APPLICATION NO.	FILING DATE	FIRST NAMED INVENTOR	ATTORNEY DOCKET NO.	CONFIRMATION NO.
10/605,892	11/04/2003	Chao-Kang Li	AOIP0008USA	2891
27765	7590	01/24/2006	EXAMINER	
NORTH AMERICA INTELLECTUAL PROPERTY CORPORATION P.O. BOX 506 MERRIFIELD, VA 22116			HAWK, NOAH CHANDLER	
			ART UNIT	PAPER NUMBER
			3637

Office Action Summary	Application No.	Applicant(s)	
	10/605,892	LI, CHAO-KANG	
	Examiner	Art Unit	
	Noah C. Hawk	3637

DETAILED ACTION

Le et al. Figure 10

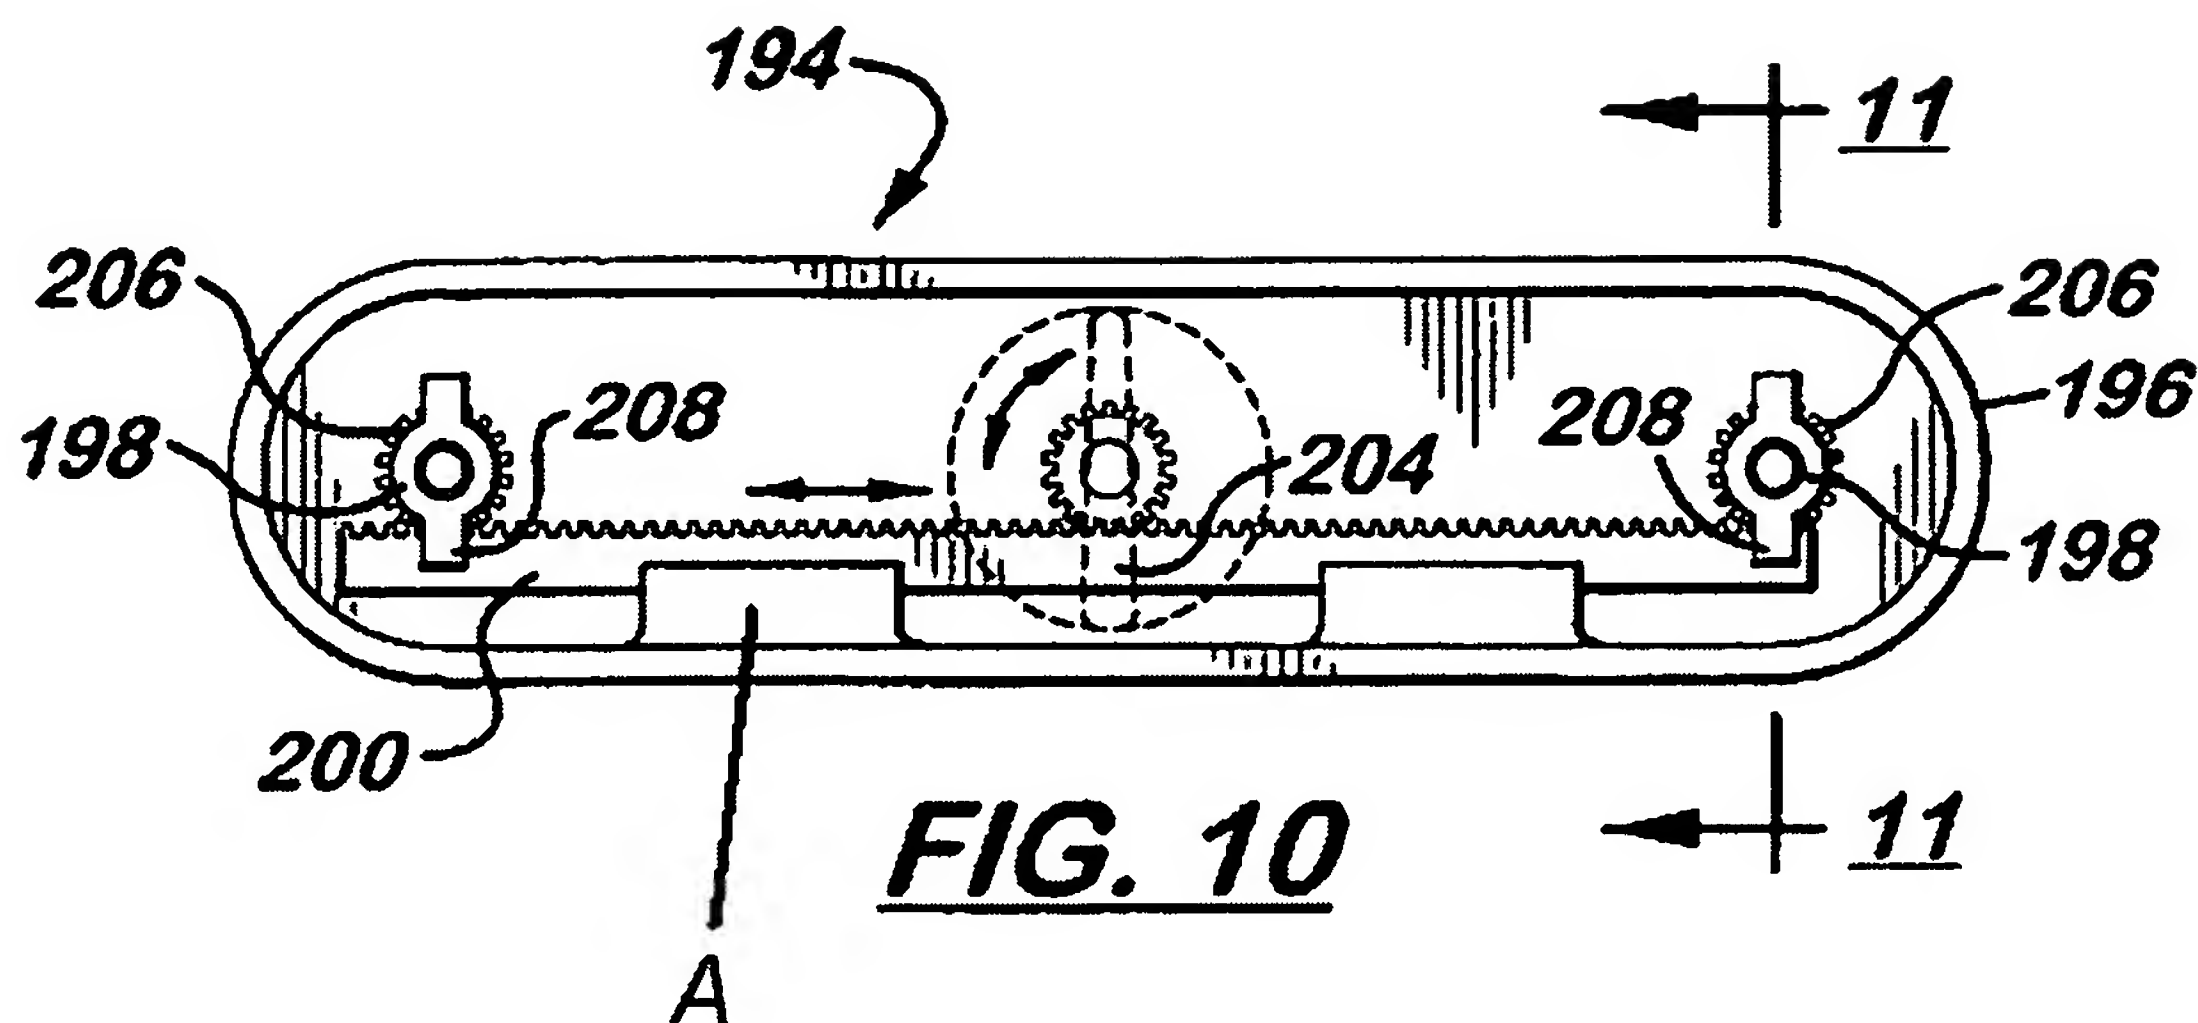
9. Regarding Claims 4 and 12, Le et al. further teach a sliding portion having a first track (200) and a fastening base (194) having a second track (A) corresponding to the first track so that the sliding portion moves with respect to the fastening base along the first and second tracks between the first and second positions.

10. Regarding Claims 7 and 15, Le et al. further teach a fastening base (194) with a first stop block and second stop block (180) on the fastening base for preventing the sliding portion from detaching from the fastening base during linear movement (see Le et al., column 7, lines 29-32).

11. Regarding Claims 17 and 18, Le et al. further teach that the fastening base (194) has an opening (the opening comprising the concave space defined by exterior wall 196 on the side of the fastening base with first track 200).

Chen et al. Figure 1

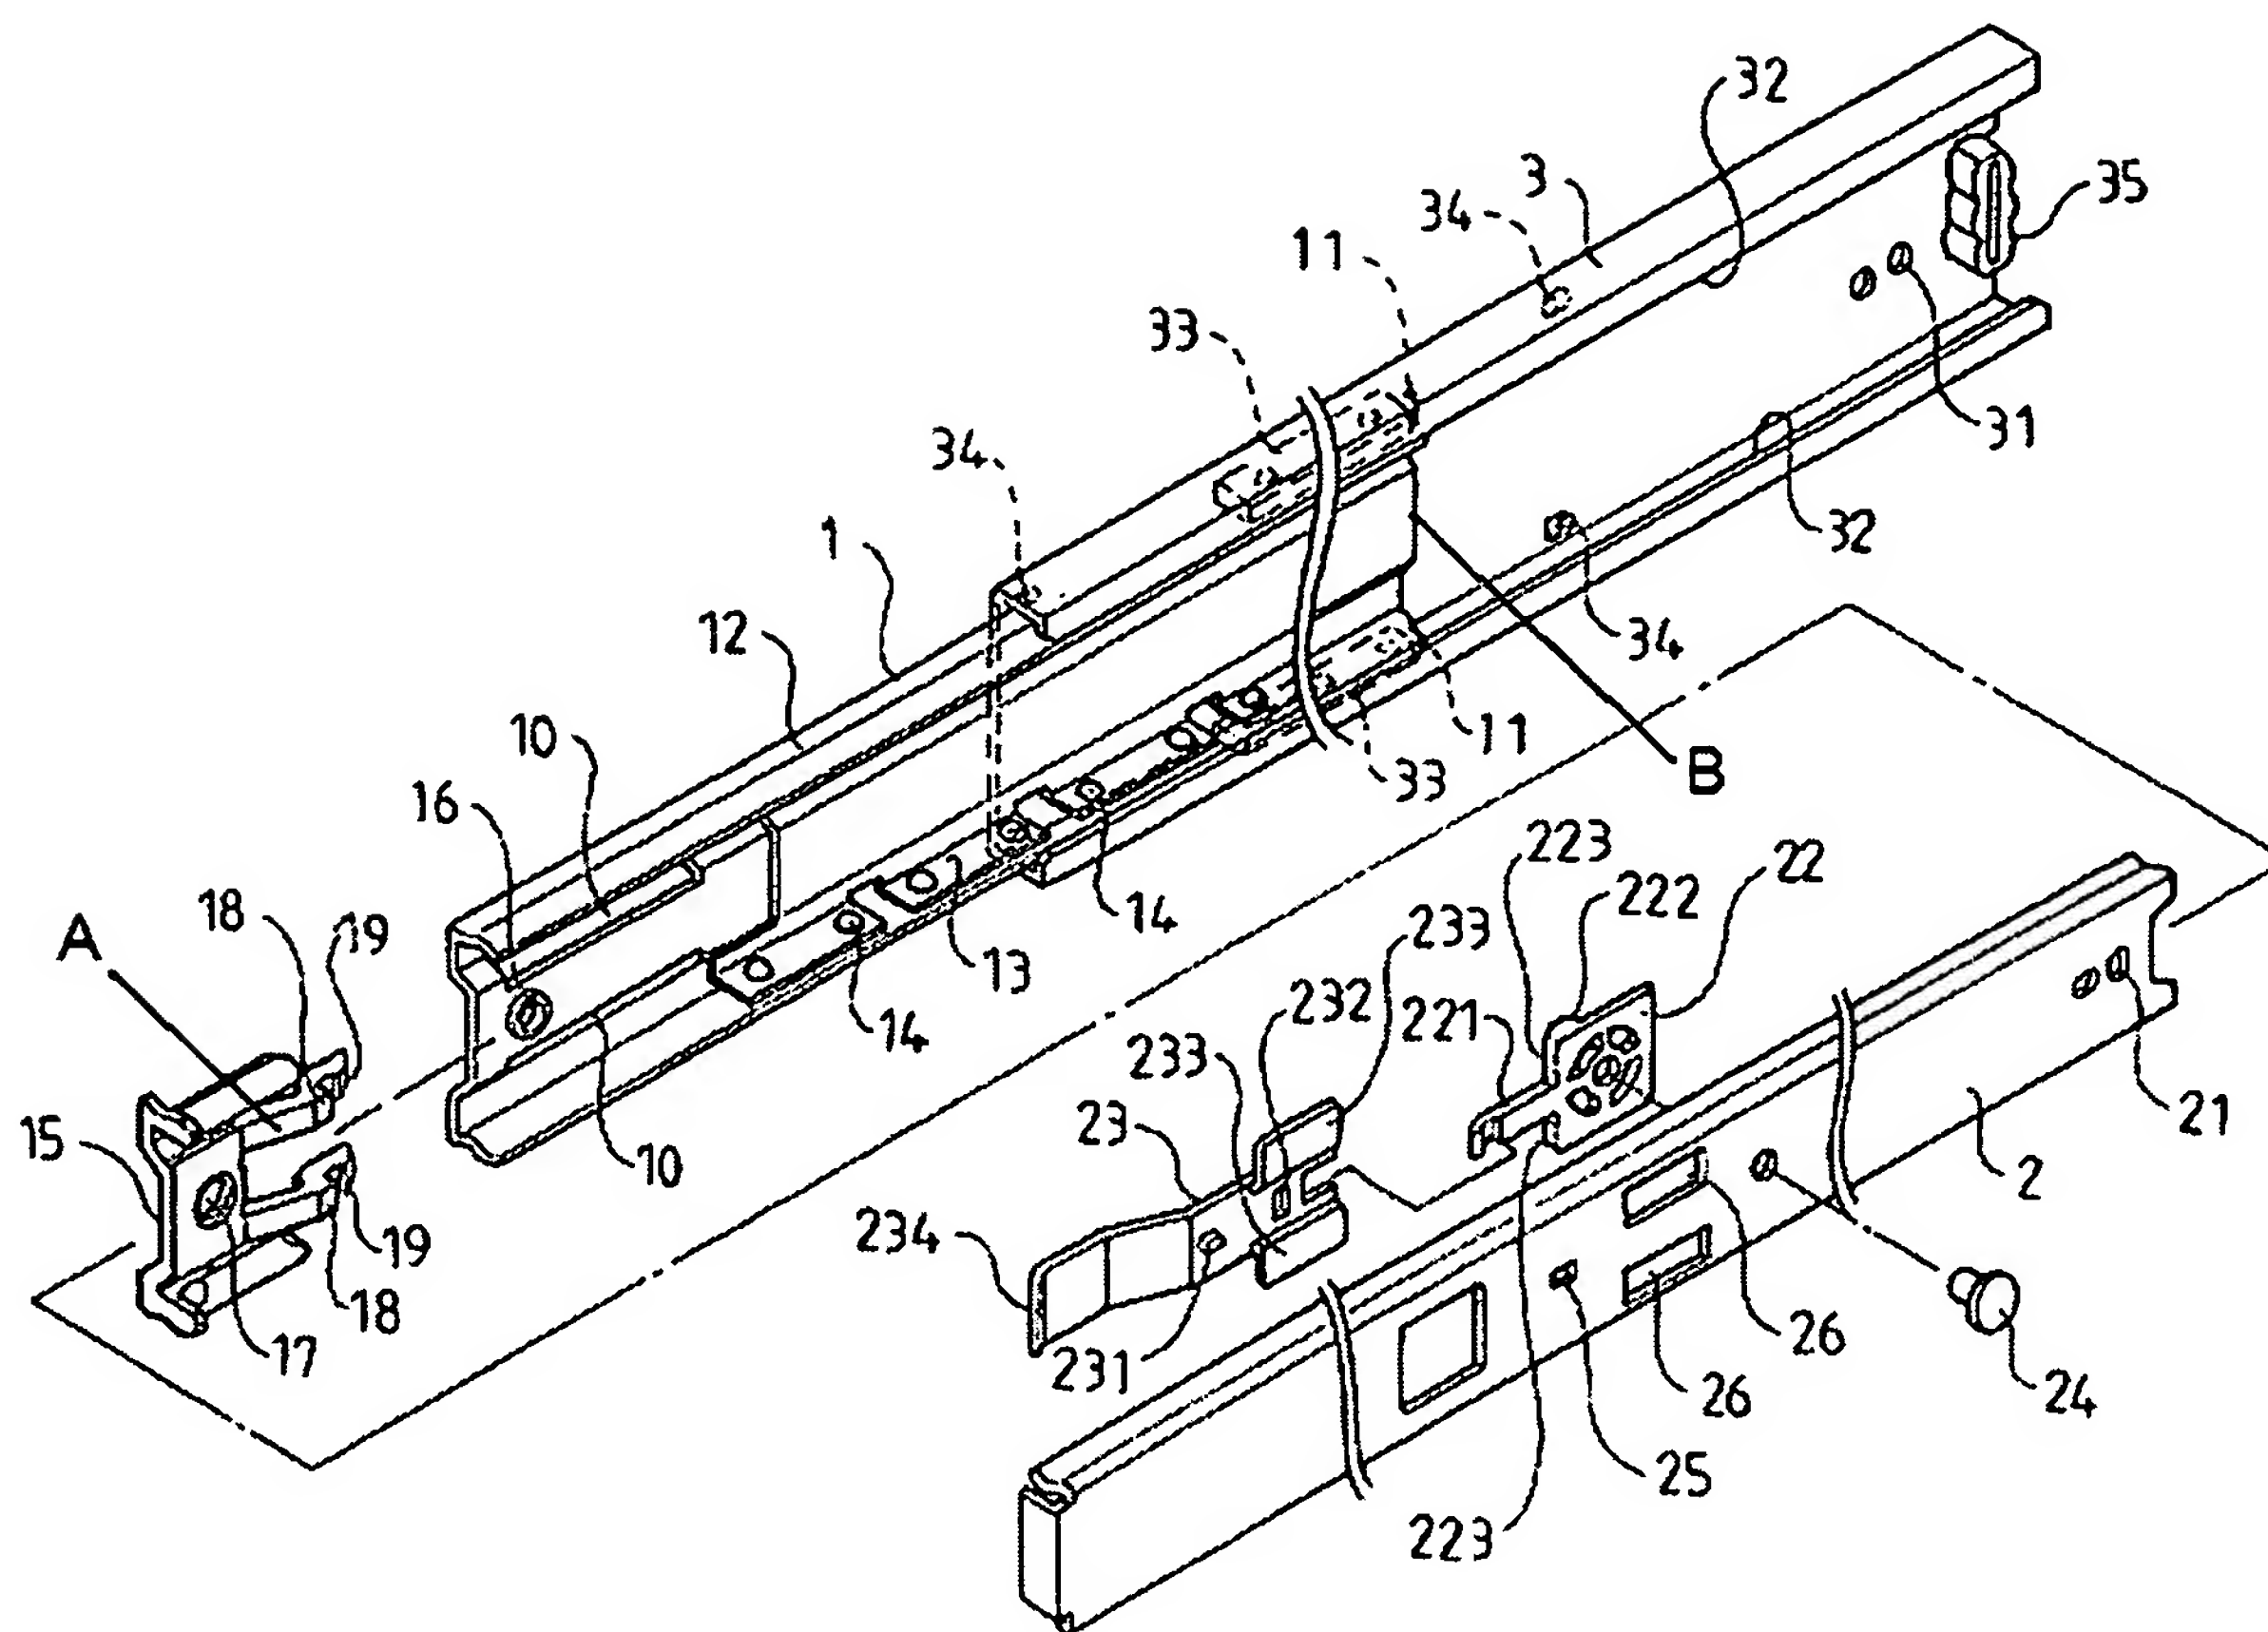
a. Regarding Claims 6 and 14, Le et al. do not disclose a first assembly error prevention assembly or a second assembly error prevention structure. Chen et al. disclose a sliding device with a sliding portion (1) having a first assembly error prevention device (B) attached to a fastening base (3) with a second assembly error prevention device (35). It would have been obvious to one of ordinary skill in the art at the time of invention to modify Le et al's storage device fastening apparatus by using first and second assembly error prevention devices as taught by Chen et al. in order to prevent assembly error.

b. Regarding Claims 8 and 16, Le et al. do not disclose a first stop block with an inclined surface. Chen et al. disclose a sliding device with a stop block (15) having an inclined surface (A). It would have been obvious to one of ordinary skill in the art at the time of invention to modify Le et al's storage device fastening apparatus by using a stop block with an inclined surface as taught by Chen et al. in order to assist in the assembly of the sliding portion with the fastening base.
